KEADBY 3 CARBON CAPTURE POWER STATION

Document Ref: 10.1

Notification of Proposed Application for a Material Change

Date: February 2022

APPENDIX A: PLAN SHOWING ORDER LIMITS UPDATES

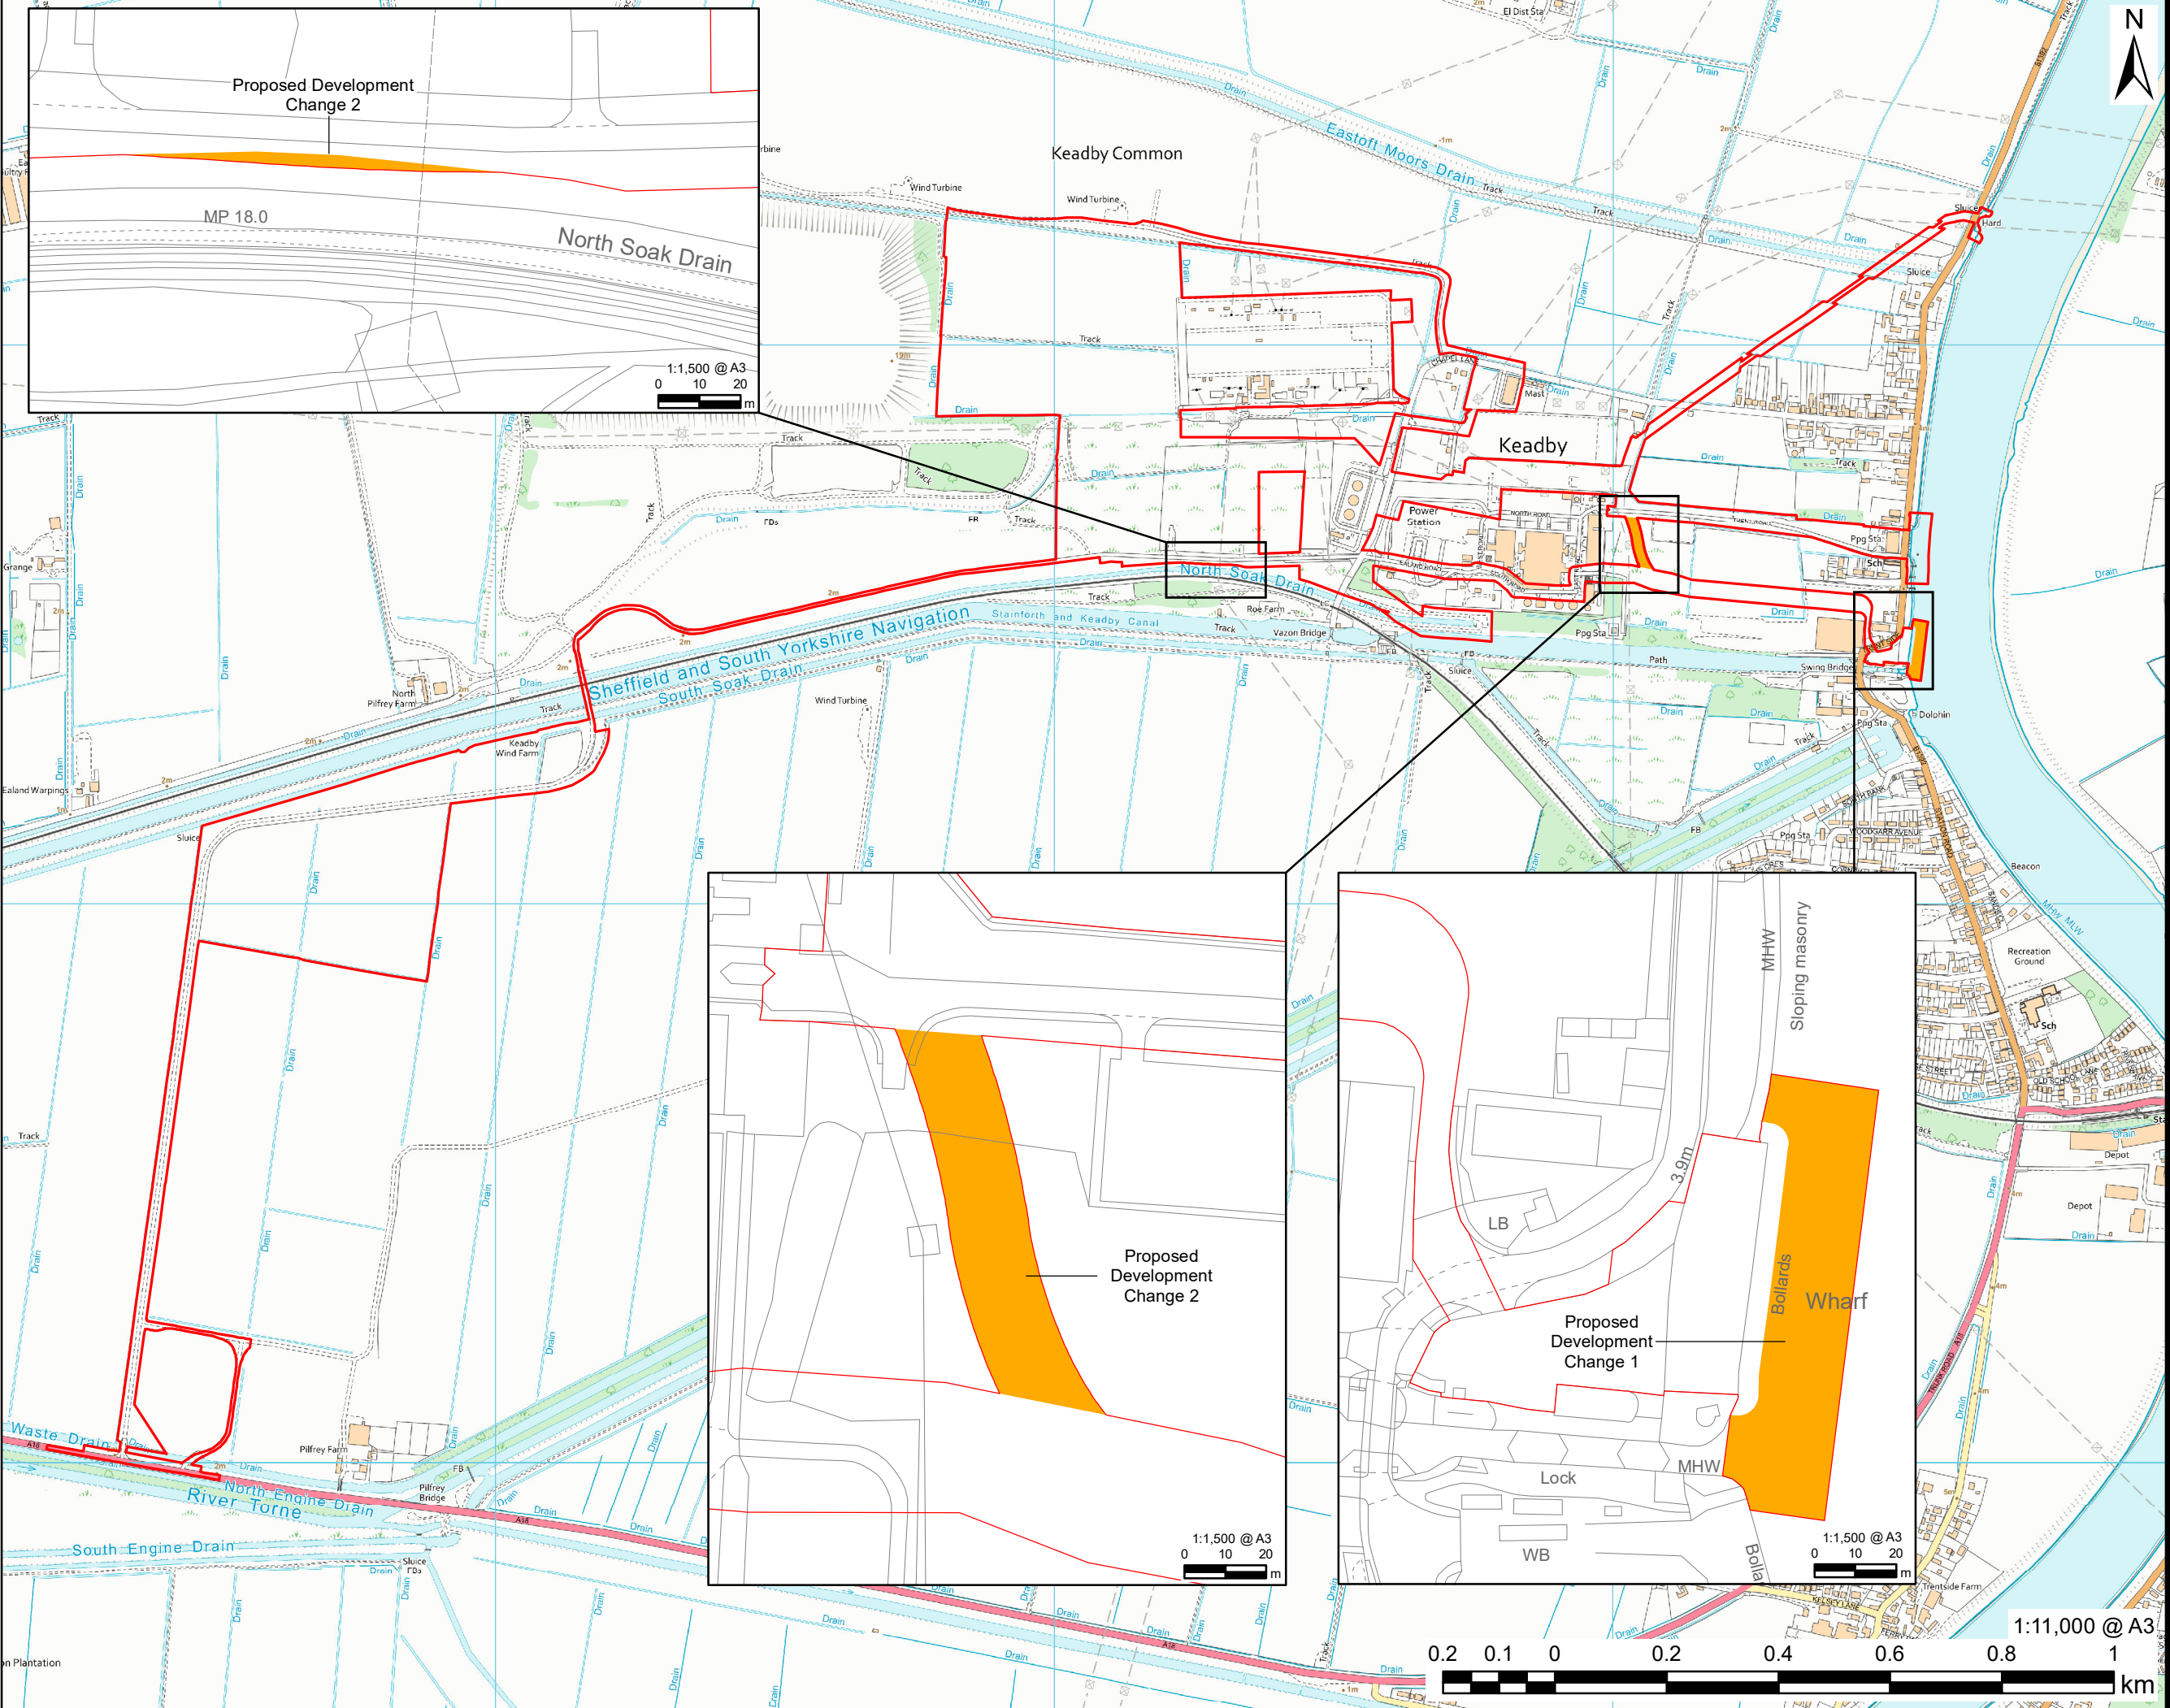
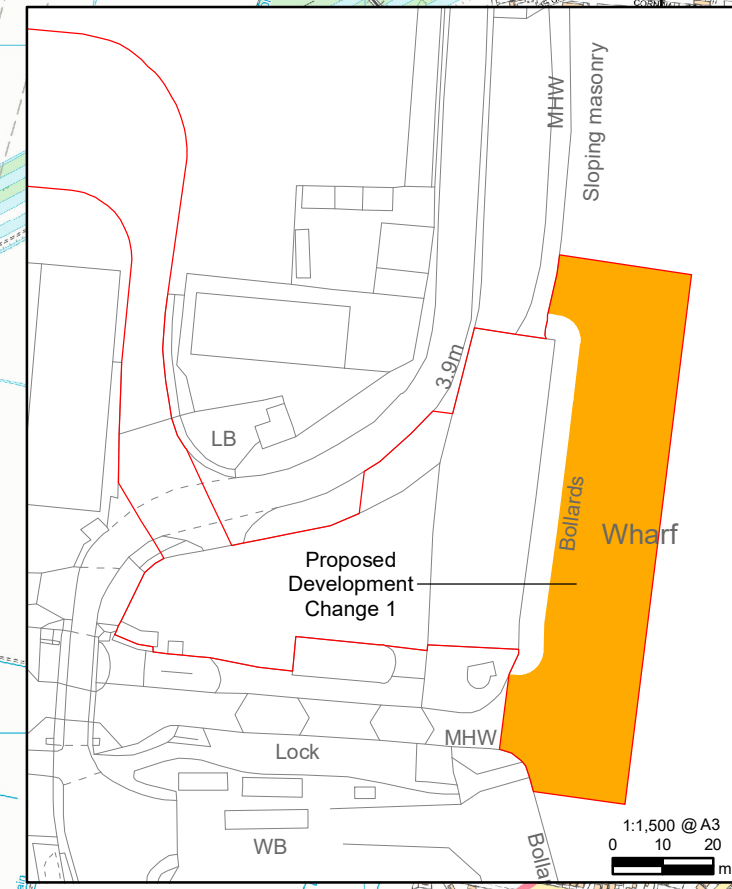
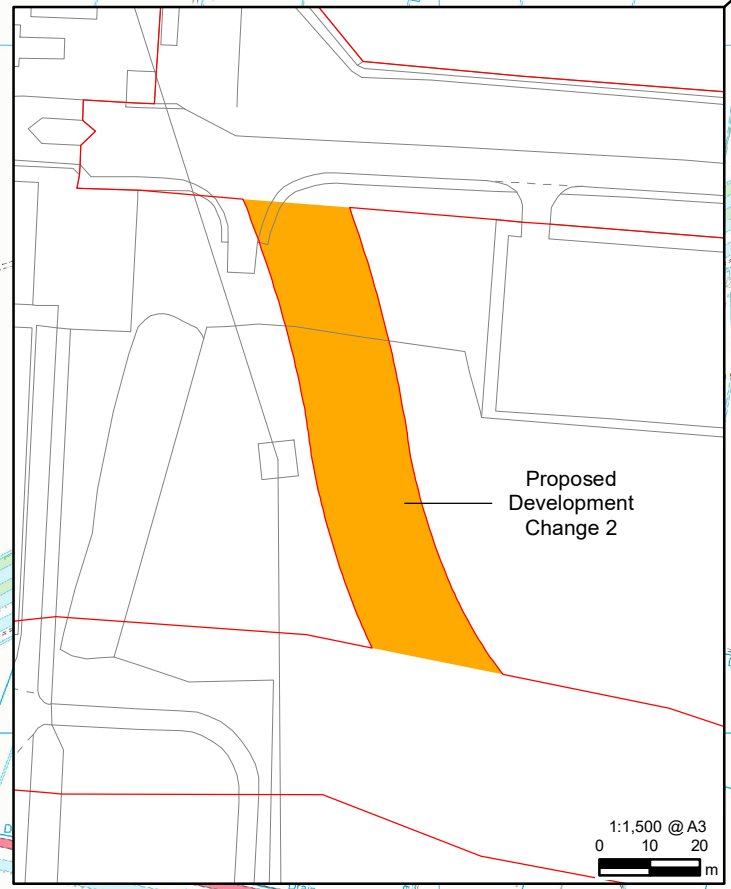
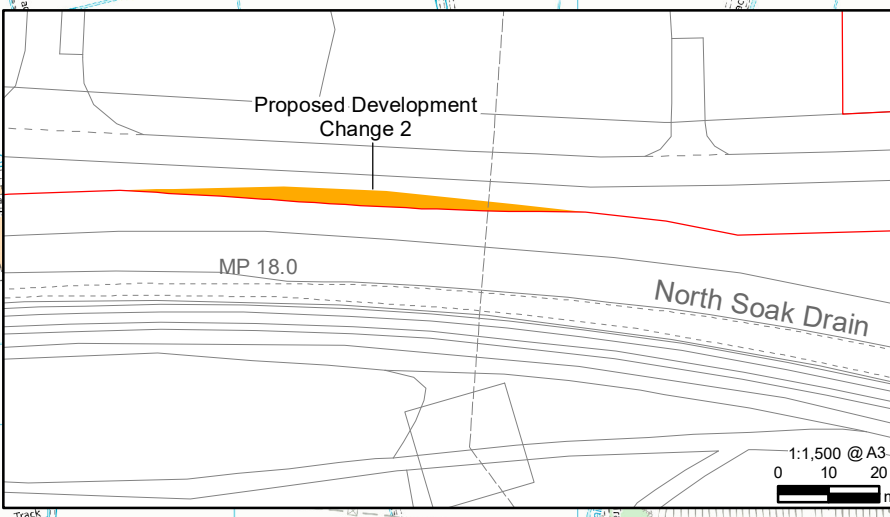
- 3.3.1 An increase in the extent of land included in the Order Limits within the River Trent which would be occupied by delivery vessels is proposed in order to accommodate the largest (82m long) potential vessels, as used here during the Keadby 2 Power Station construction project. Where vessels are required to be moored for the full tide cycle, they could require use of the sea bed, which is Crown Land and as such, it is intended to negotiate voluntarily for rights for this. The proposed revised Order Limits are presented in **Appendix A**.

- 3.3.6 A very minor increase (0.02ha) to the Order Limits south of Bonnyhale Road is also proposed to allow oversail of the largest AIL components. This area is within the Applicant's land.
